Project description . . : RESTORATION OF PORTAL EAST ELEVATION  
Project number . . . . : 97- 10100152  
Case Number . . . . . : H-97-131  
Project type . . . . . : HISTORIC DESIGN REVIEW BOARD  
Application date . . . : 09/18/97

PROJECT LOCATION(S) : 439 A Camino Del Monte Sol

DATE: 14 October 1997

CASE # H-97-131 ADDRESS 439 A Camino del Monte Sol (Main Residence)

439-A East Elevation showing Bay Window and Arched Doors to be removed.

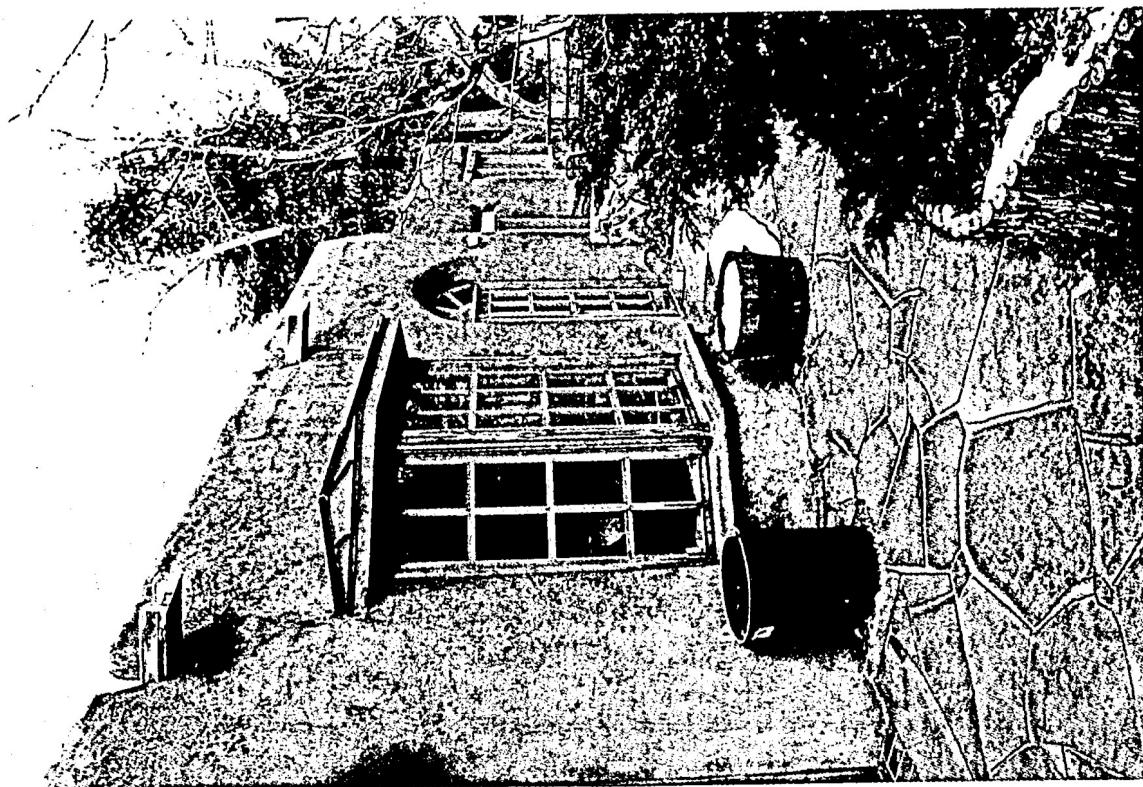
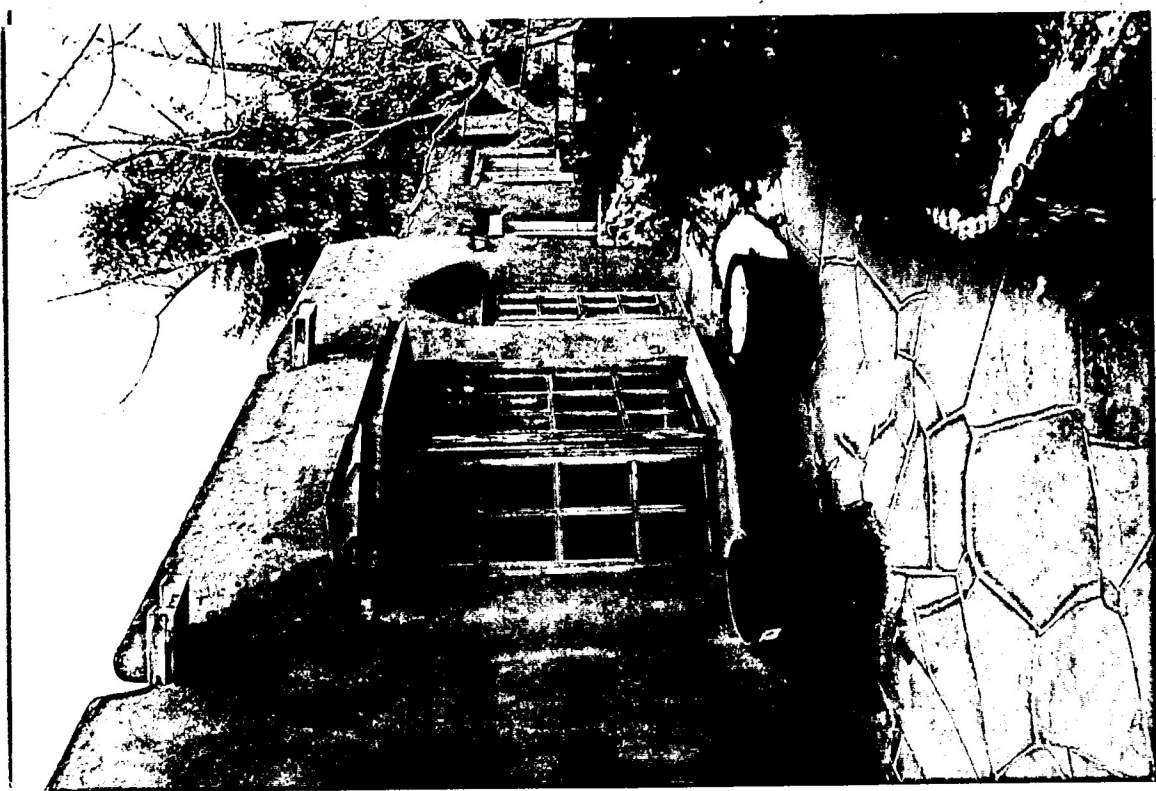
Staff acknowledges the architectural standards for design in the Downtown and Eastside Historic District have been met. Relative to preservation standards, the proposed alterations are occurring on a non-historic portion of the subject building and will not affect the "contributing" status of the building as required by Section 14-70.73A1 SFCC 1987.

The applicant has provided illustrations for the removal of an east elevation addition (including arched doors and a bay window) to restore the elevation's original profile. The New Mexico Historic Building Inventory Form indicates that the subject elevation has been altered through the addition of the bay window and arched openings. The applicant proposes to remove the aforementioned arched doors and bay window and convert the space into a portal. The heavy massing which currently exists between the openings will be retained so as not to create a false sense of historical development or conjectural feature as required by Section 14-70.71A SFCC 1987. As well, new true-divided-lite French doors will be inserted beneath the portal. Stucco will match that existing and exposed wood lintels will be a weathered grey to match those existing on the same elevation. The wall beneath the portal will be painted white.
